Amendments to the Drawings:

REMARKS/ARGUMENTS

The present amendment is submitted in response to the Office Action dated December 12, 2006, which set a three-month period for response, making this amendment due by March 12, 2007.

Figure 1

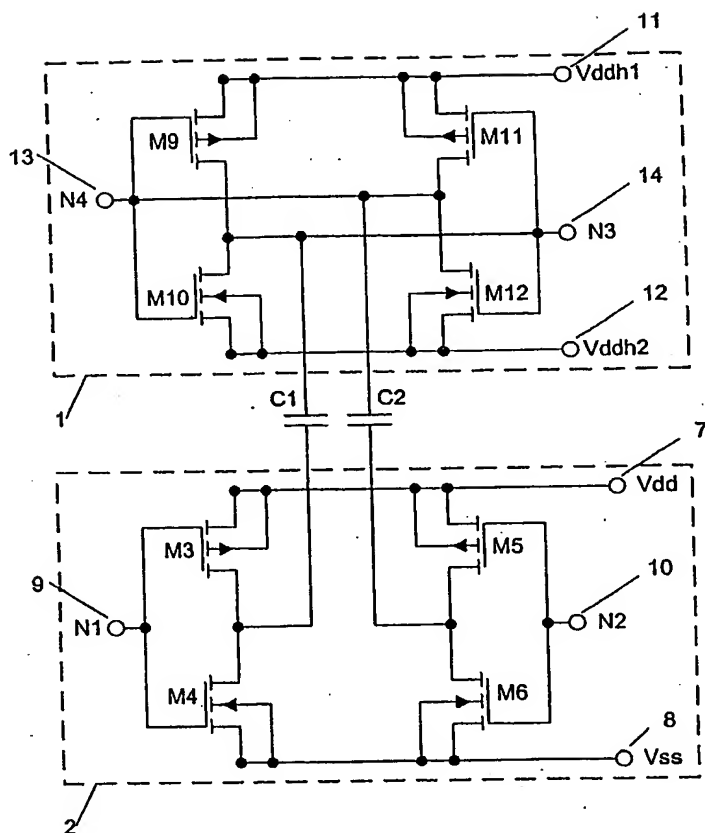
The attached sheet of drawings includes changes to Figs. 1-5. These sheets replace the original sheets including Figs. 1 – 5. In all of the figures, the term “Figur” was replaced by “Figure”. In Fig. 5, the boxes have been labeled.

Regarding the objection raised under paragraph 8 in the Office Action (page 4), the Applicants respectfully disagree that the figures do not show the inputs to the inverters being complementary to each other. In Figs. 1 through 4, the inputs N1 and N2 are clearly shown as inputs: the inputs of the first inverter circuit (3) and the second inverter circuit (4), respectively, of the voltage transmitter (2), which are a non-inverted and inverted input, comprise two inverted circuits 3, 4, whose outputs are simultaneously the outputs of the voltage transmitter 2. The Applicants therefore submit that the limitation as recited in claim 10 is not indefinite.
